Gatwick Airport Northern Runway Project

Examination Ref: TR020005

Joint Local Authorities' Response to the Applicant's Deadline 8 Submissions

Deadline 9: 21 August 2024

Figure 1. Comparison of Awakenings with 48 dB LAeq 8h noise contour based on 2032 central case fleet with project.

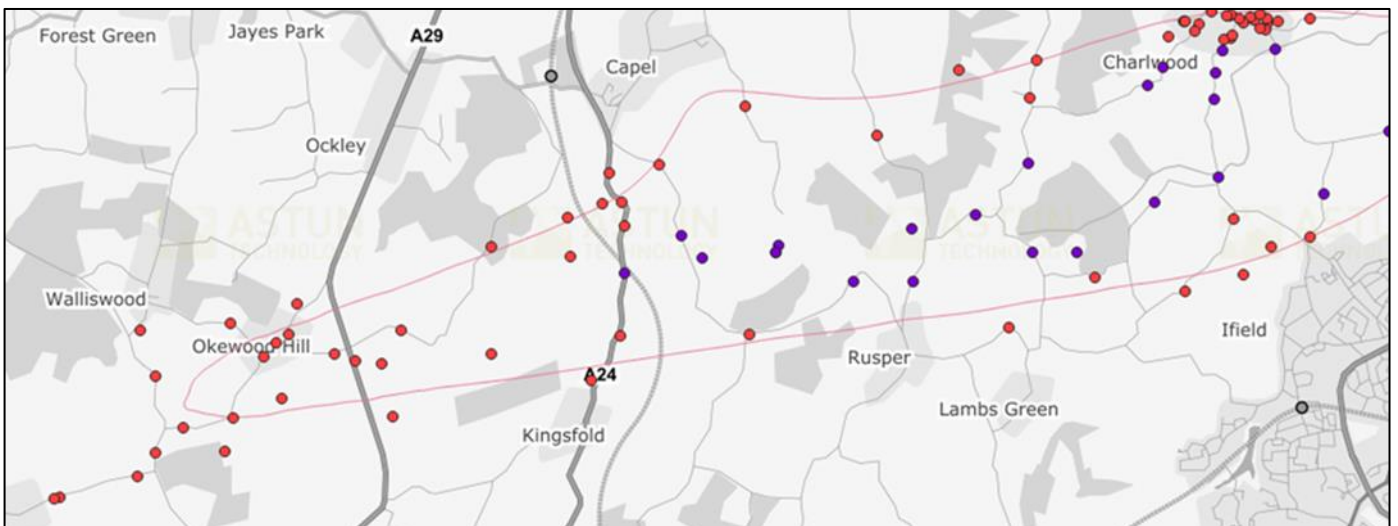
6.5 Further to [REP7-103] the JLAs have identified further evidence to demonstrate how the one additional awakening does not correspond with the 48 dB LAeq 8h. This location is to the West of the airport.

6.6 The data was provided to the JLAs and that shown is the 2032 central case fleet with project. As can be seen there are many locations where there is more than one additional noise induced awakening beyond the 48 dB LAeq8h average mode contour. Therefore, extending the night noise insulation only to the 48 dB LAeq8h will result in individuals experiencing SOAEL due to the exceedance of the one additional noise induced awakening contour.

- 6.7 Therefore, the JLAs consider that this is sufficient to merit the inclusion of the metric as a control in the noise envelope and the noise insulation scheme.
- 6.8 The JLAs note that only 2032 data is available. The Applicant must provide a full analysis for all scenario years. The data must be presented and interpreted in accordance with Basner’s methodology.

Figure 1 Daytime 51 dB LAeq, 16h Noise Contour Area Compared to ExA Proposal for Noise Area Reduction

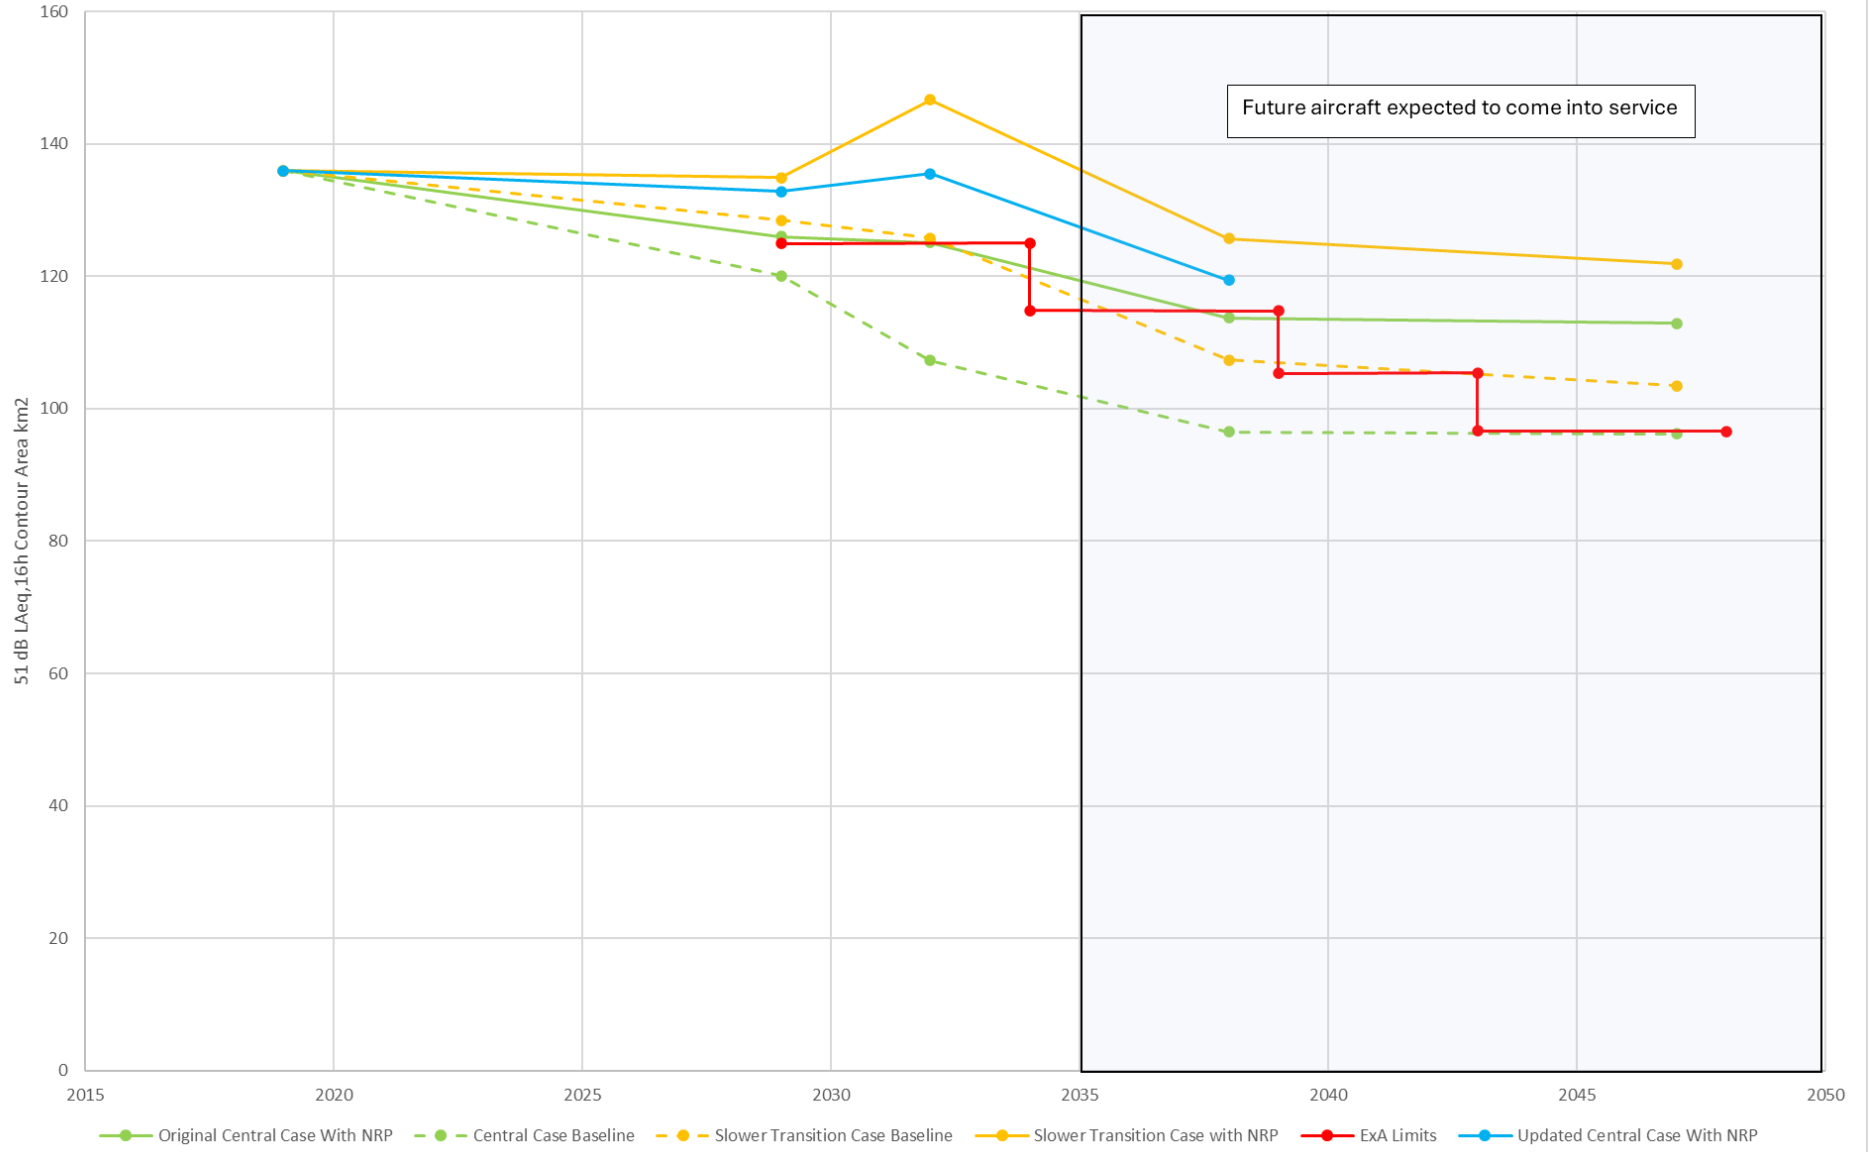
13. Figure 1 for the daytime 51dB $L_{Aeq,16h}$ noise contours:
 - the Central Case baseline would be below the ExA's proposed noise limits until they converge in 2038.

- The Central Case with project broadly follows the ExA's noise limits, but it would be challenging to meet the noise limits after they drop in 2034 unless account is taken of ICAO's expectation for ongoing noise reductions with further new aircraft types is met.

- Both baseline and with project slow transition case fleet are above the noise limits at all times so would not be workable in terms of their fleet transition rates.

- The updated Central Case with project is above the noise limits at all times so would not be workable in terms of their fleet transition rates.
14. Figure 2 for the night time 45 dB $L_{Aeq,8h}$ contours:

Figure 2: Night time 45 dB LAeq,8h Noise Contour Areas

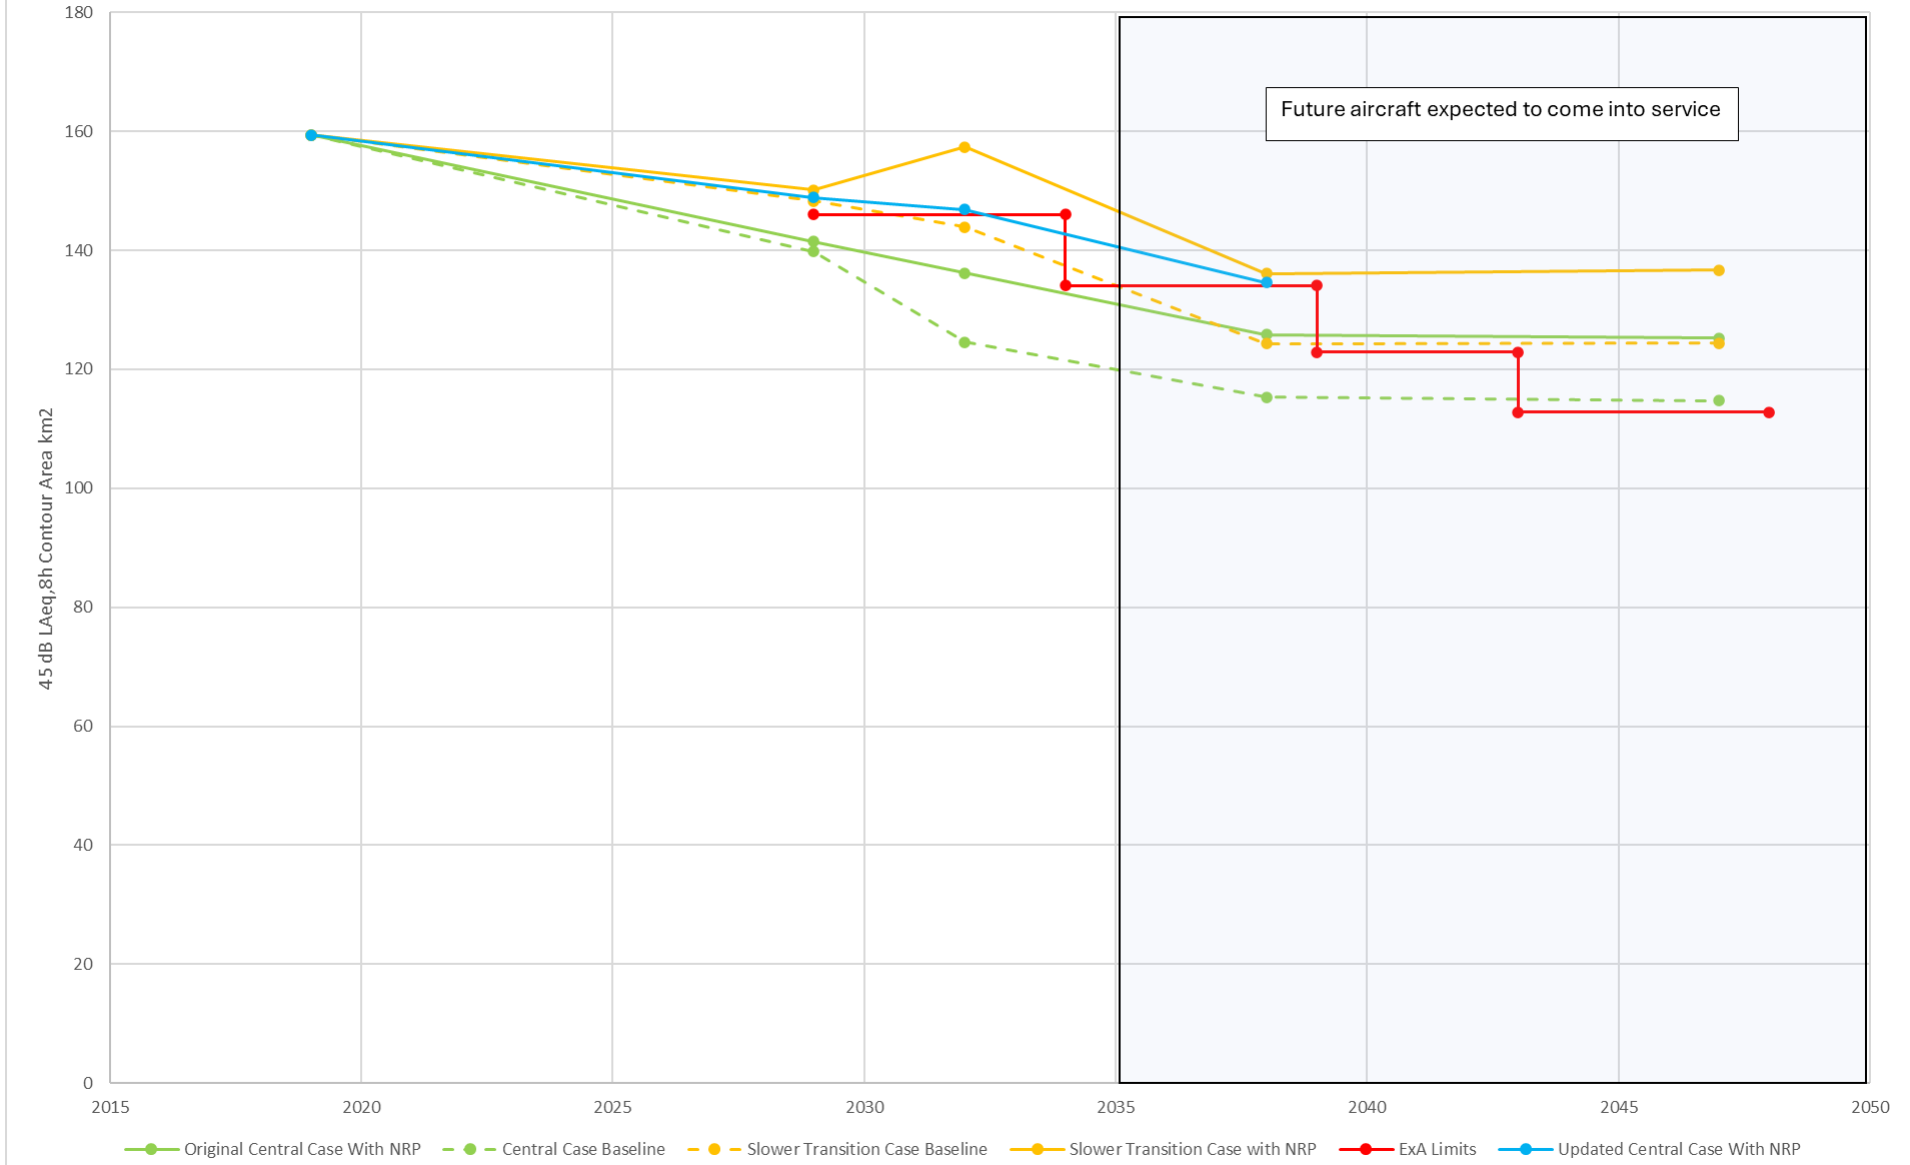
- the Central Case baseline is below the ExA's proposed noise limits until they almost converge in 2038. This is similar to the day.
 - The Central Case with project is also below the ExA noise limits up to 2039, at which point, the contour area plateaus. However, it is possible that future aircraft may continue the trend of noise reductions. Thus, compliance with the ExA limits after 2039 could be possible but it is acknowledged that it would be challenging. As with the daytime figure, the STC and the UCC are above the noise limits at all times so would not be workable in terms of their fleet transition rates.

- Slow transition with project would not comply whereas the slow transition baseline shows potential for compliance, but it is not certain,
 - The Updated Central Case with project would not comply.
